Docket Nos. 50-280
and 50-281

Change No. 15
Licenses Nos. DPR-32
and DPR-37

CHANGE NO. 15 TO THE TECHNICAL SPECIFICATIONS

SAFETY EVALUATION BY THE DIRECTORATE OF LICENSING

Figure 2.1-1 Reactor Core Thermal & Hydraulic Safety Limits - Three Loop Operation, 100% Flow

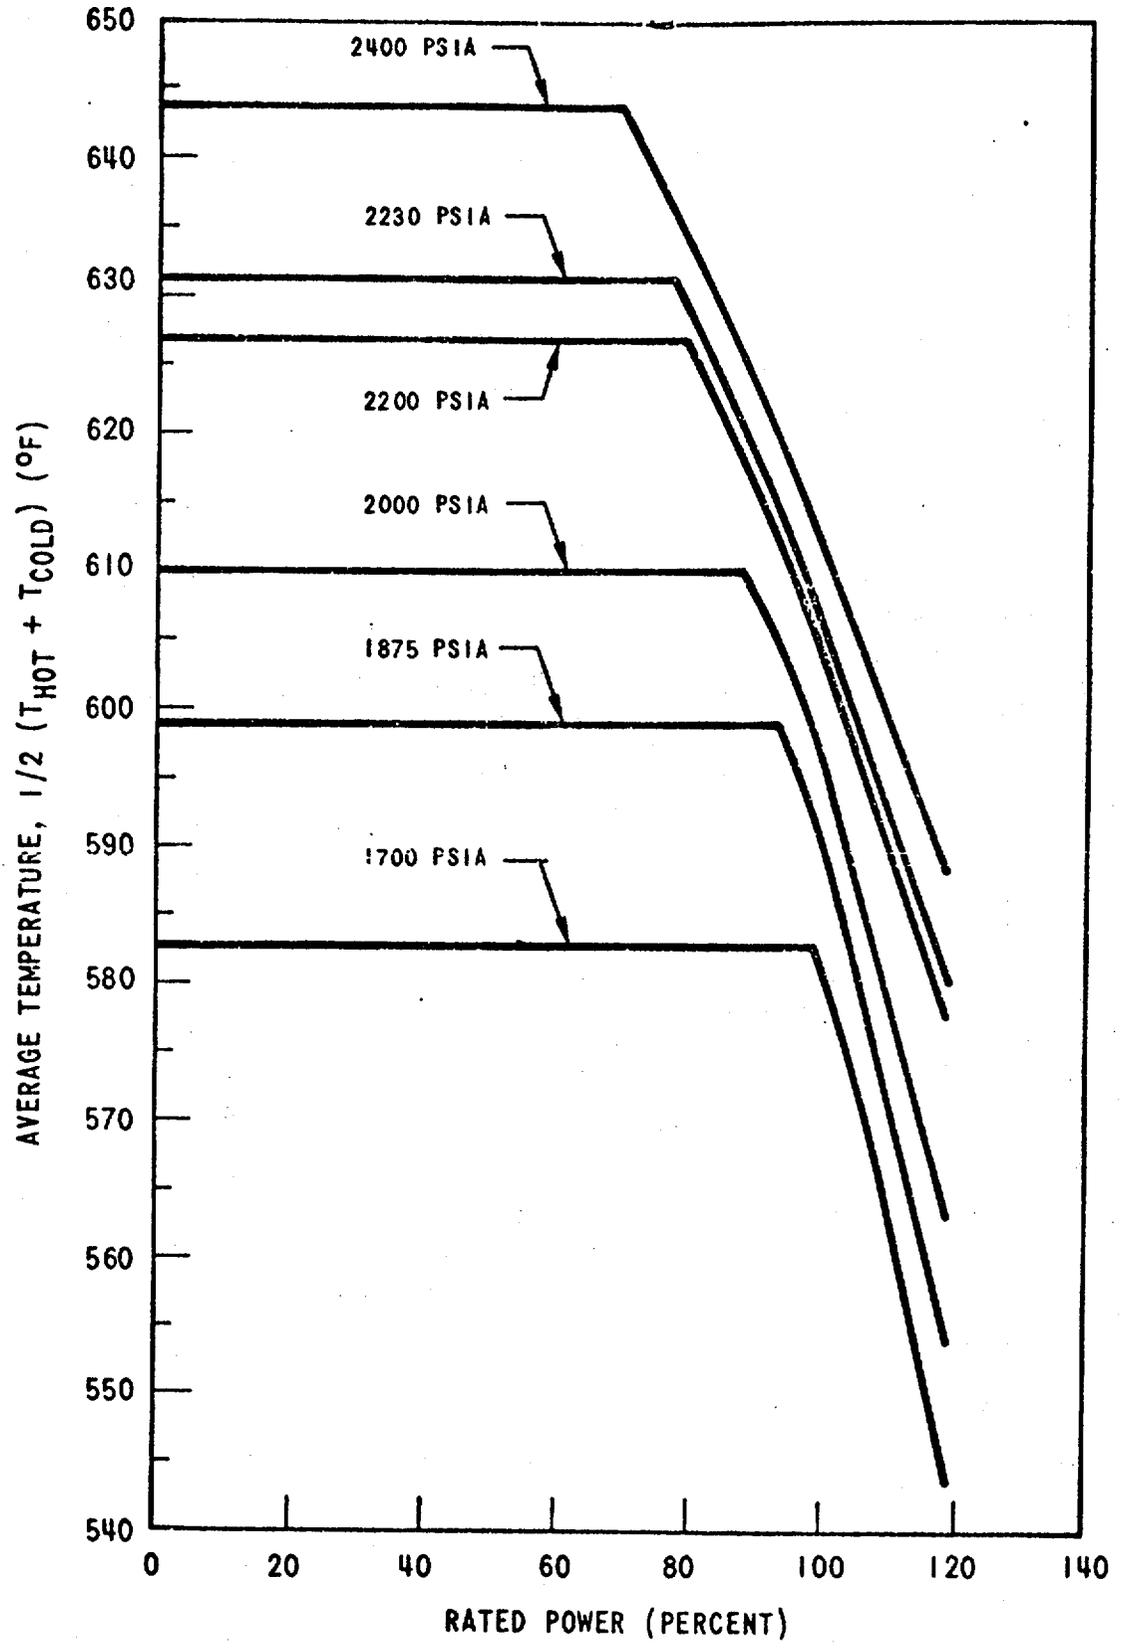
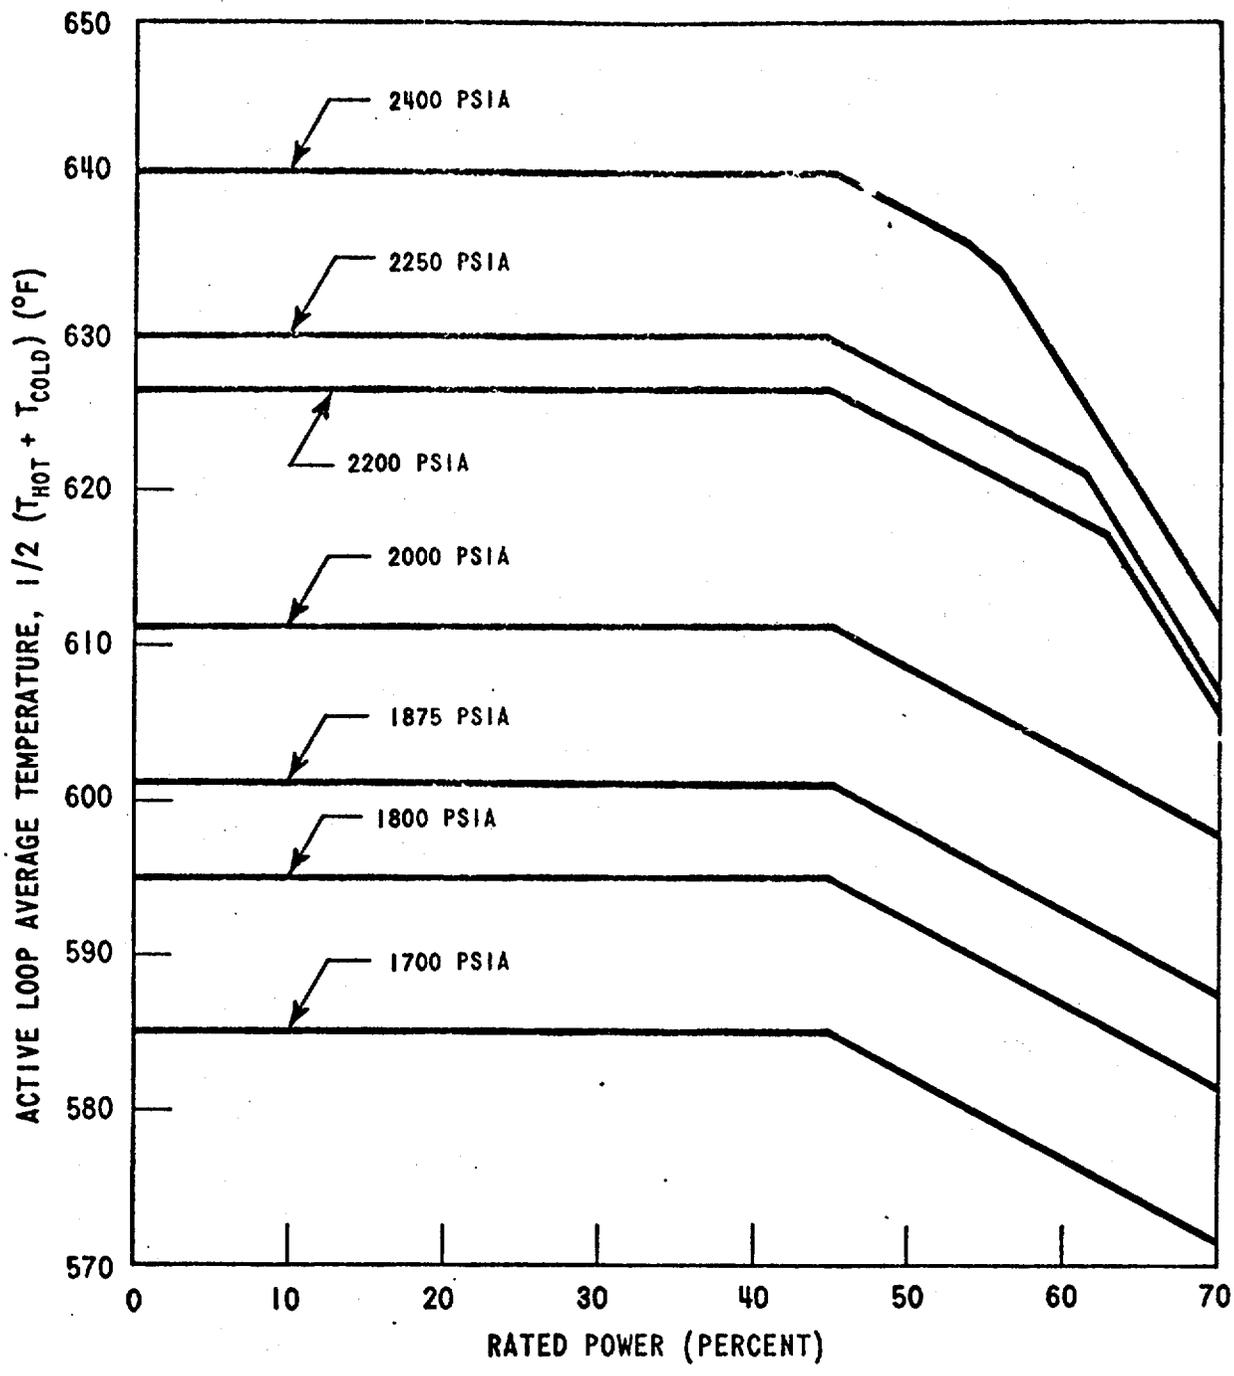
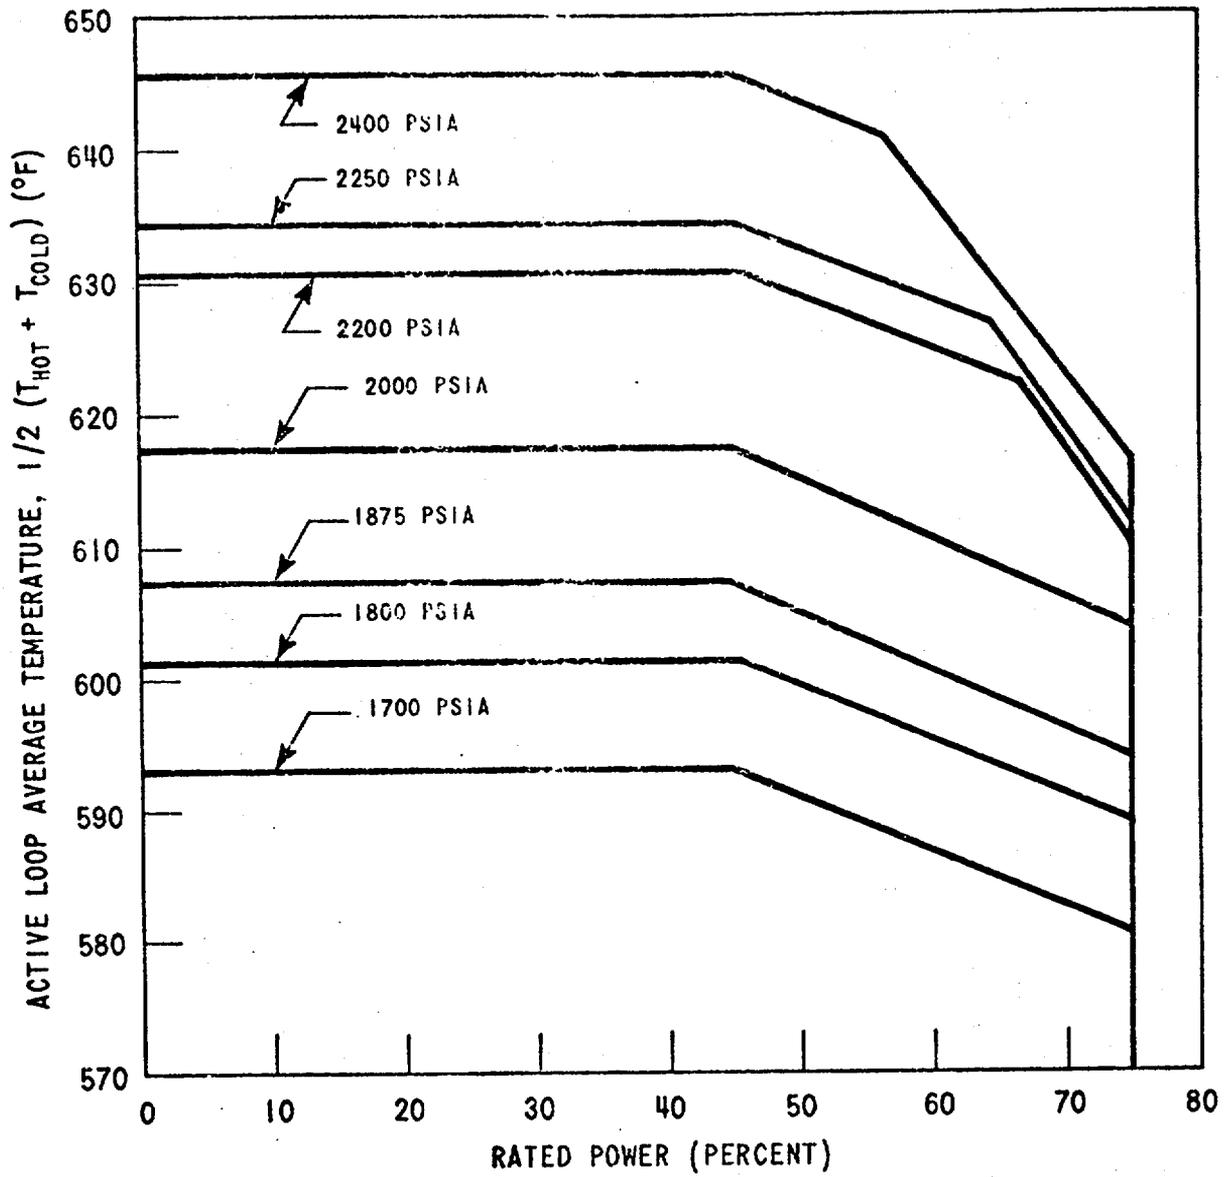
The curves of TS Figure 2.1-1 which show the allowable power level decreasing with increasing temperature at selected pressures for constant flow (three loop operation) represent the loci of points of thermal power, coolant system average temperature, and coolant system pressure for which the DNB ratio is not less than 1.30. The area where clad integrity is assured is below these lines. In order to completely specify limits at all power levels, arbitrary constant upper limits of average temperature are shown for each pressure at powers lower than approximately 75% of rated power. The temperature limits at low power are considerably more conservative than would be required if they were based upon a minimum DNB ratio of 1.30 but are such that the plant conditions required to violate the limits are precluded by the self actuated safety valves on the steam generators. The three loop operation safety limit curve has been revised to allow for heat flux peaking effects due to fuel densification.

The curves of TS Figures 2.1-2 and 2.1-3, which show the allowable power level decreasing with increasing temperature at selected pressures for constant flow (two loop operation), represent the loci of points of thermal power, coolant system average temperature, and coolant system pressure for which either the DNB ratio is equal to 1.30 or the average enthalpy at the exit of the core is equal to the saturation value. At low pressures or high temperatures the average enthalpy at the exit of the core reaches saturation before the DNB ratio reaches 1.30 and, thus, this arbitrary limit is conservative with respect to maintaining clad integrity. In order to completely specify limits at all

power levels, arbitrary constant upper limits of average temperatures are shown for each pressure at powers lower than approximately 45% of rated power. The limits at low power as well as the limits based on the average enthalpy at the exit of the core are considerably more conservative than would be required if they were based upon a minimum DNB ratio of 1.30. The plant conditions required to violate these limits are precluded by the protection system and the self actuated safety valves on the steam generator. Upper limits of 70% power for loop stop valves open and 75% with loop stop valves closed are shown to completely bound the area where clad integrity is assured. These latter limits are arbitrary but cannot be reached due to the Permissive 8 protection system setpoint which will trip the reactor on high nuclear flux when only two reactor coolant pumps are in service. TS Figures 2.1-2 and 2.1-3 have not been revised as these have been found to be adequate and conservative even including the heat flux peaking effects due to fuel densification.

TS Figures 2.1-1, 2, and 3 are based on a $F_{\Delta H}^N$ of 1.55; a 1.55 cosine axial flux shape and a DNB analysis as described in Section 4.3 of the report Fuel Densification Surry Power Station, Unit 1 dated December 6, 1972 (including the effects of fuel densification). They also include an allowance for an increase in the enthalpy rise hot channel factor based on the expression:

FIGURE 2.3-1

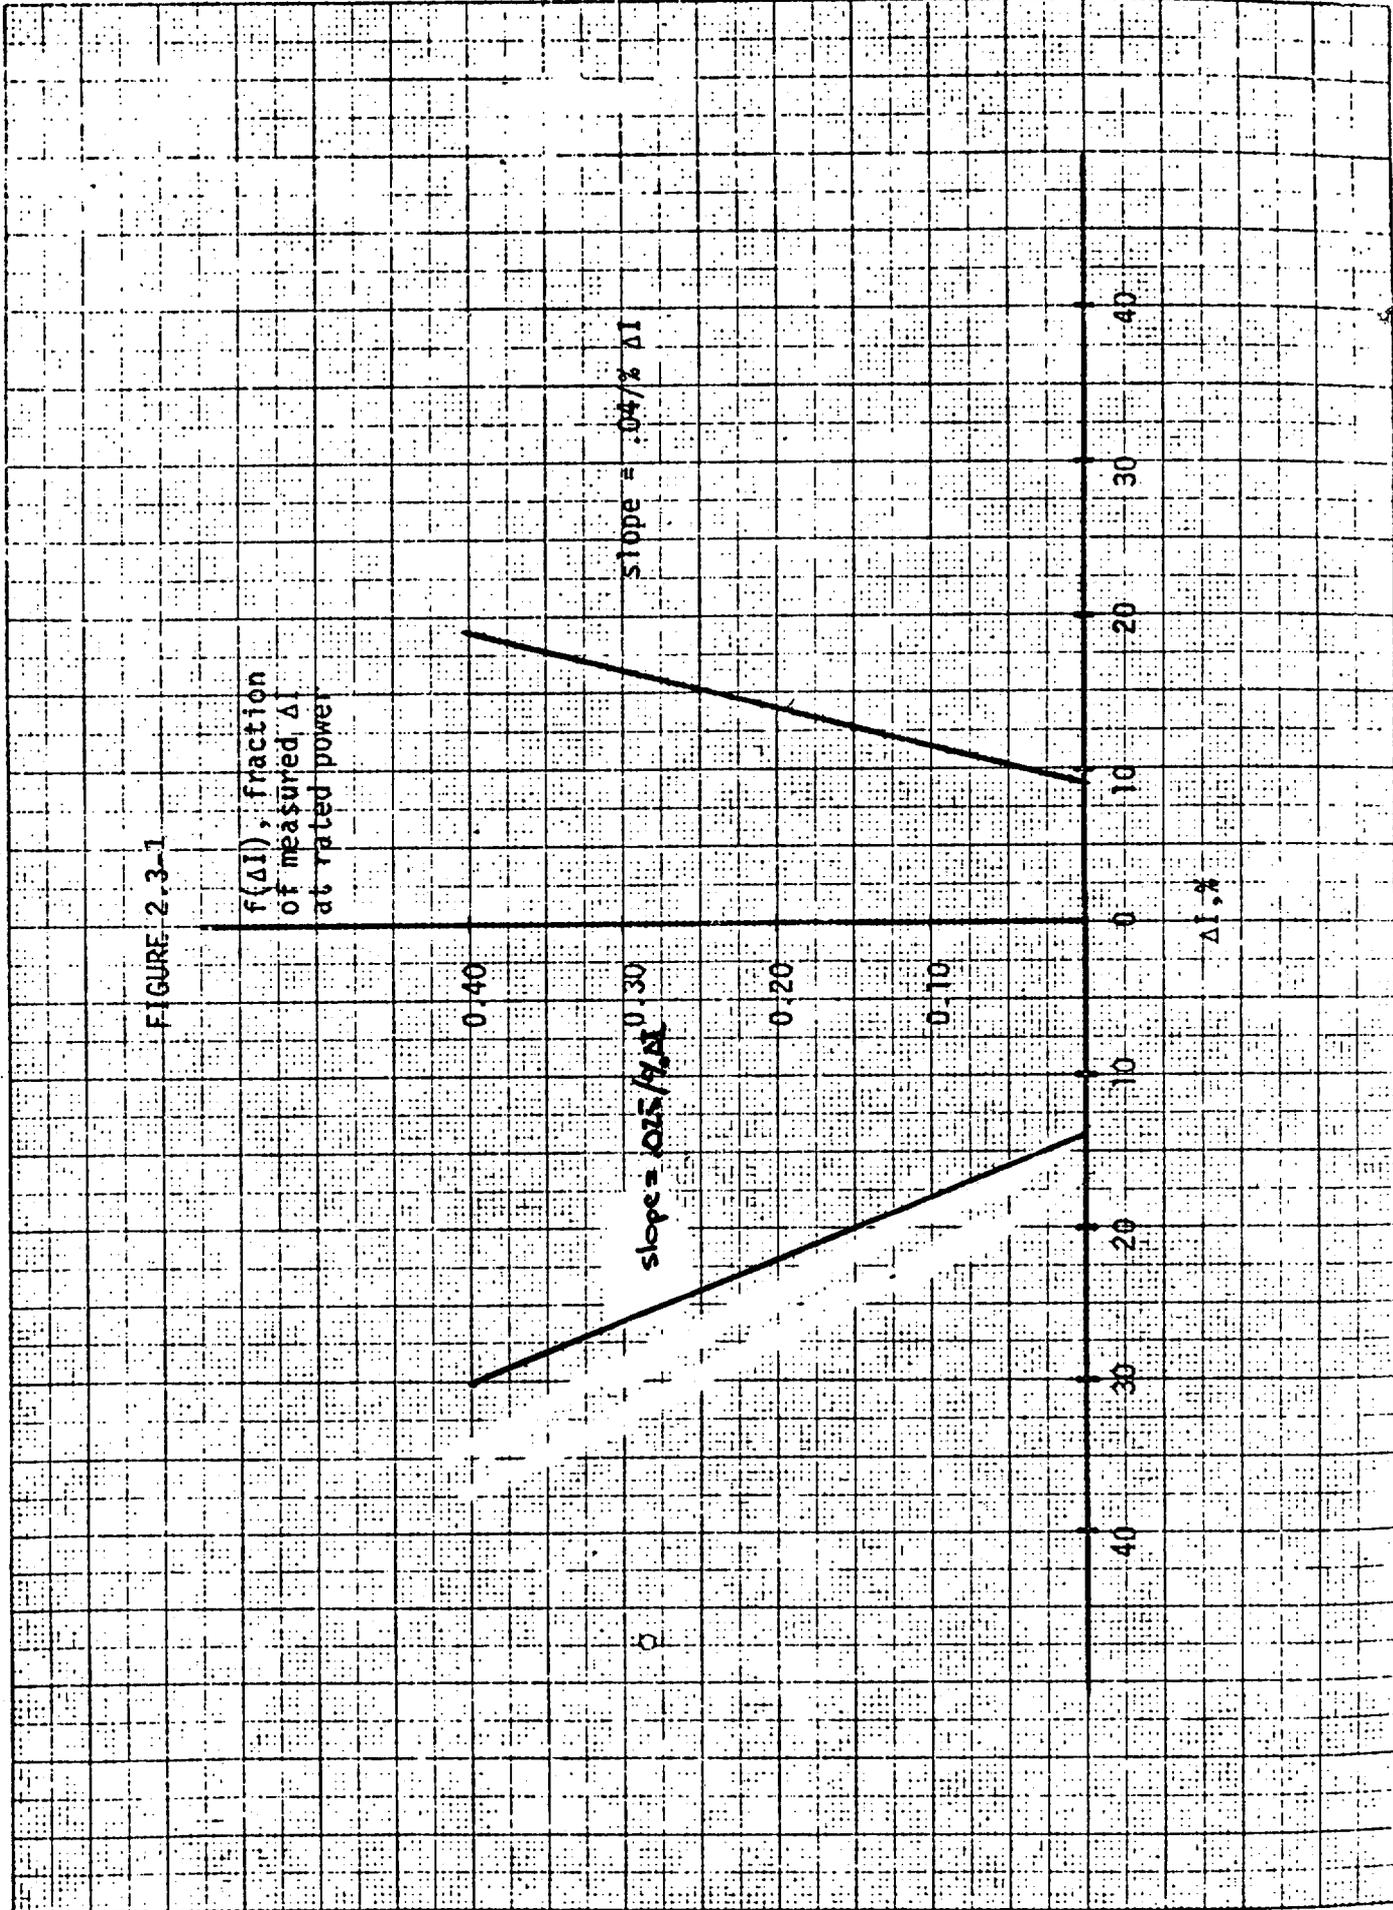
$f(\Delta I)$ = function of ΔI , percent of rated core power as shown in Figure 2.3-1
